RE: PAWNEE STREET TRIPLEX (K-22/D47). ENGINEER'S CERTIFICATION FOR
CERTIFICATE OF OCCUPANCY, ENGINEER'S STAMP DATED 8/18/97.

RE: REVISED DRAINAGE PLAN FOR PAWNEE STREET TRIPLEX (K22-D47)
ENGINEER'S STAMP DATED 7/24/97

RE: DRAINAGE PLAN FOR PAWNEE STREET TRIPLEX (K22-D47) ENGINEER'S
STAMP DATED 2/27/97

AS-BUILT GRADING AND DRAINAGE PLAN

GRADING AND DRAINAGE PLAN
LOT 7, BLOCK 3 OF BLOCKS 1-19 OF CHELWOOD PARK
915 PAWNEE ST. N.E.
ALBUQUERQUE, BERNALILLO COUNTY, NEW MEXICO

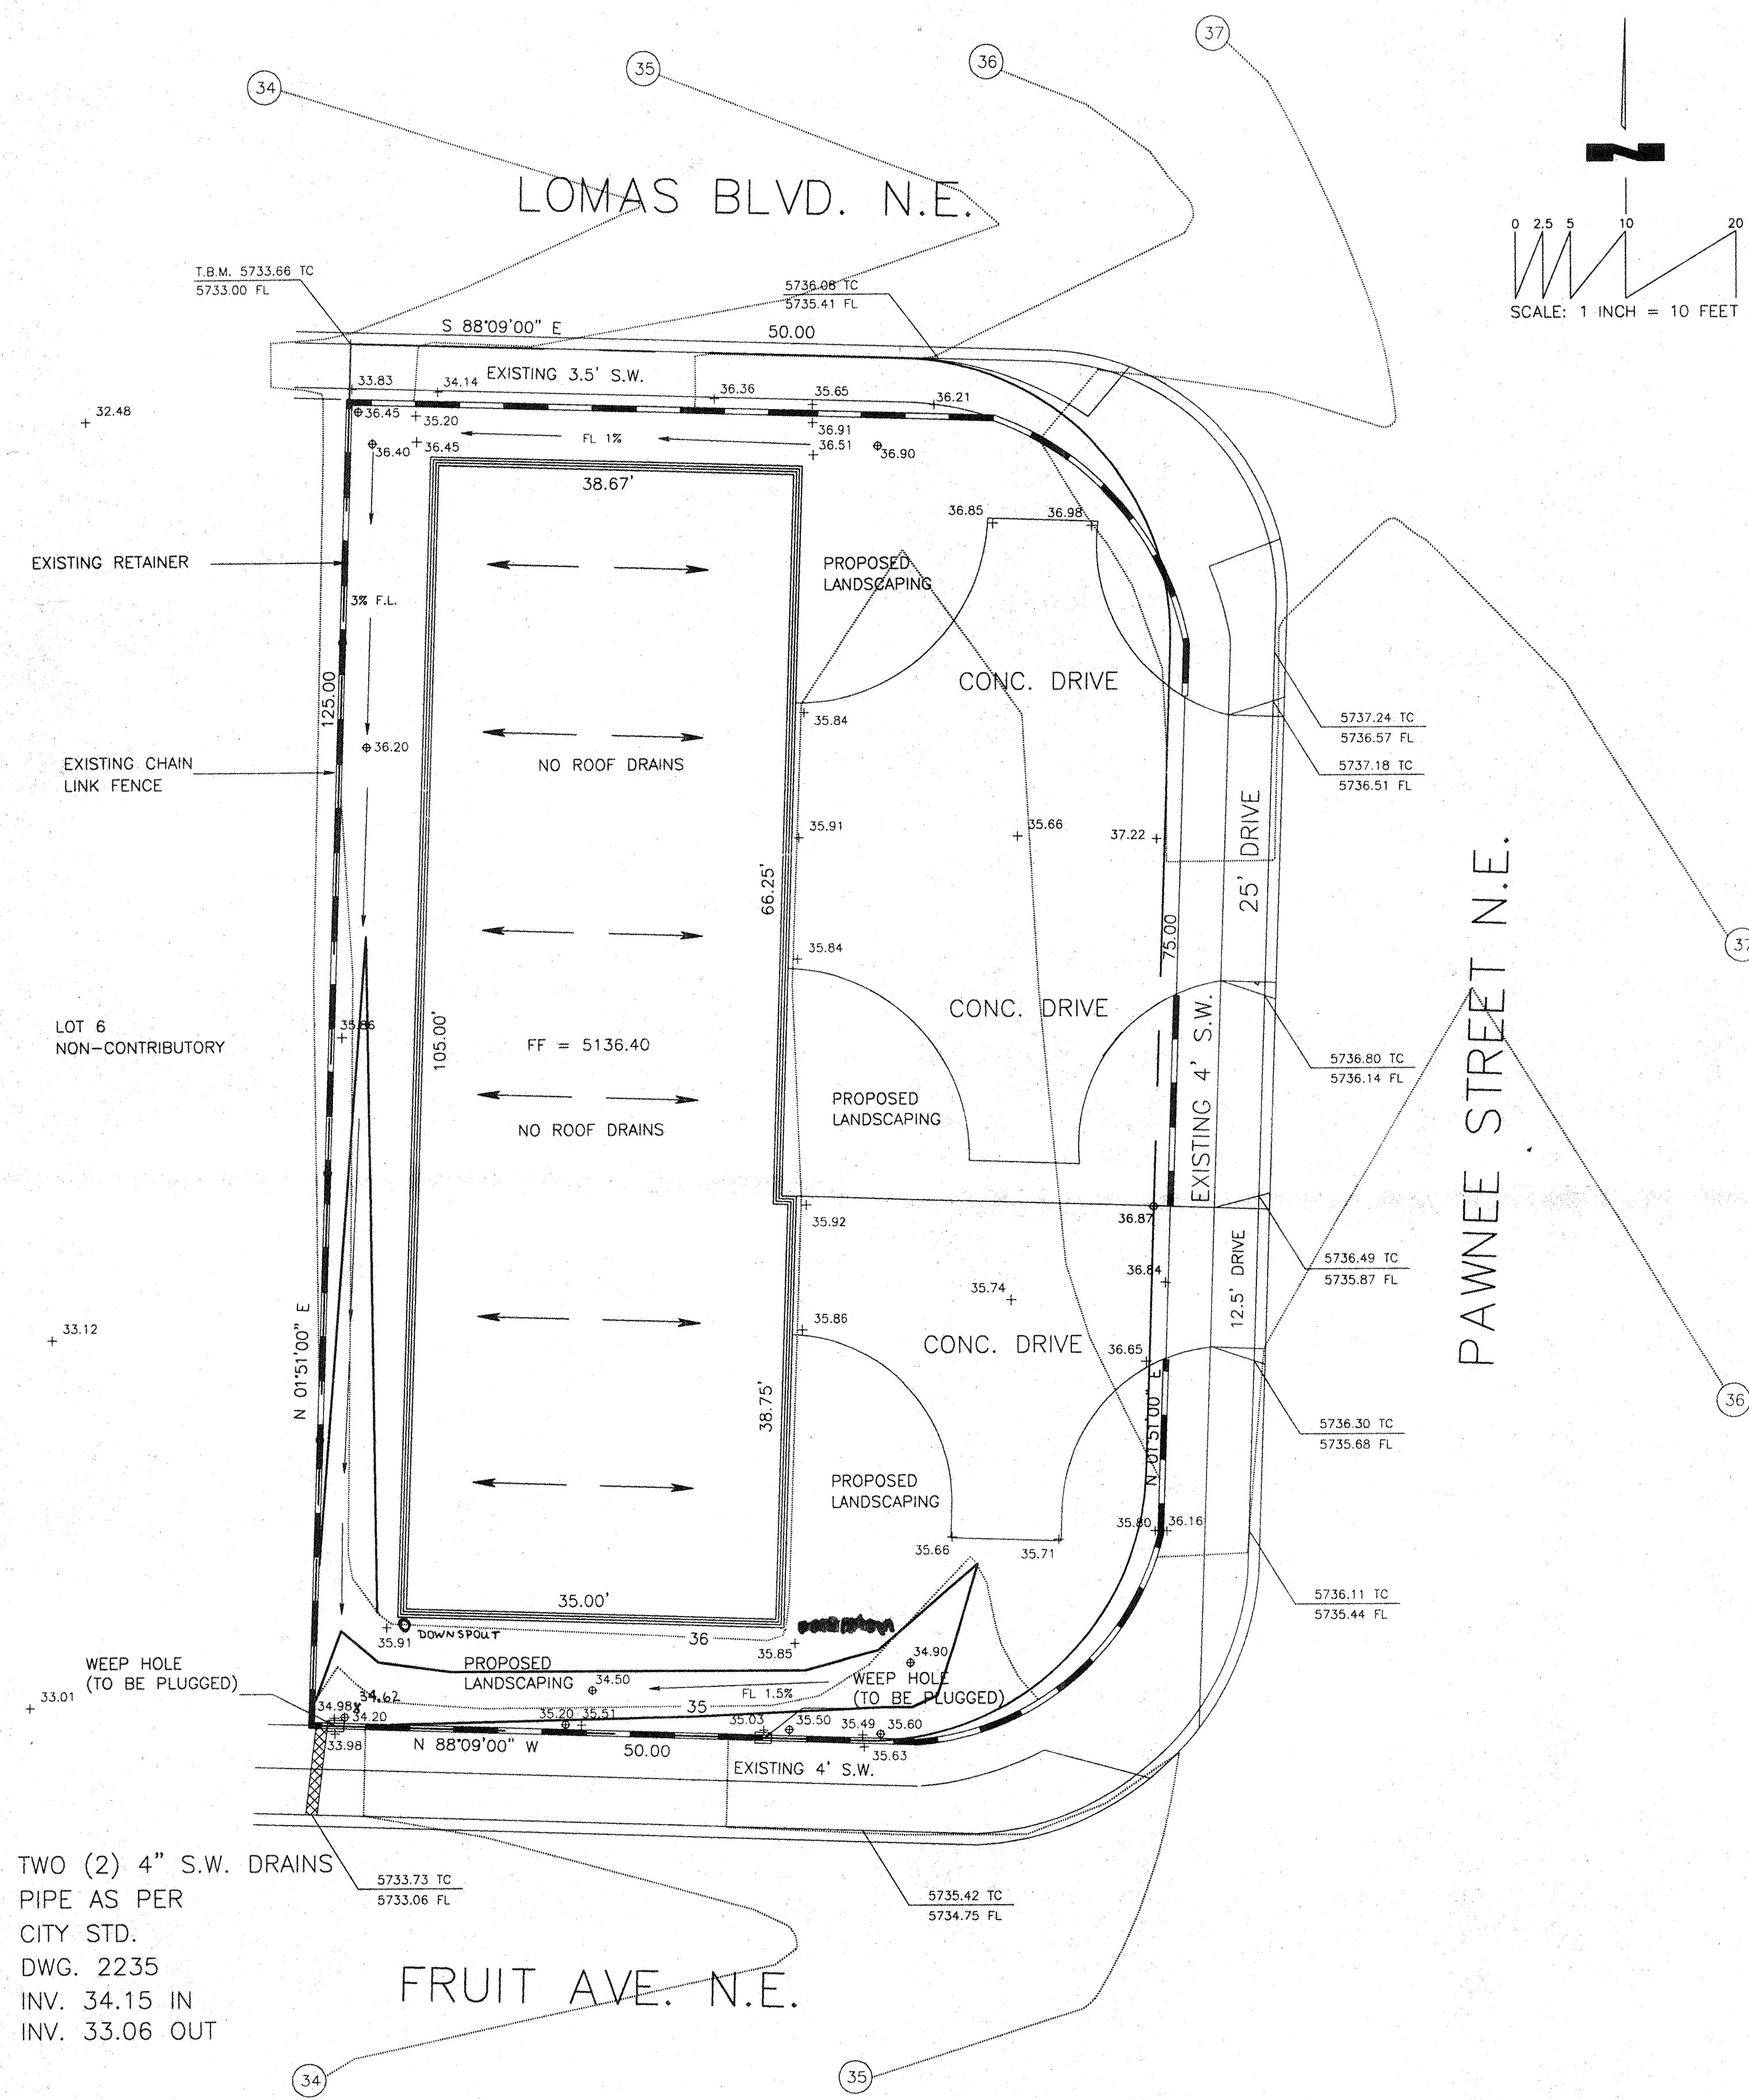
Based on the information provided on your February 27, 1997 submittal, listed are some concerns that will need to be addressed prior to final approval:

1. Pipe Hydraulics for the proposed 4" pvc pipe (include the entry capacity).
2. TBM must be permanently marked with a curb notch or painted.
3. Roof runoff (East portion) must be routed towards the concrete drive.(Recommend downspouts)
4. Please address off-site flows from the West if any.
5. Spot elevations required 25' west of the proposed retaining wall to evaluate any off-site flows.
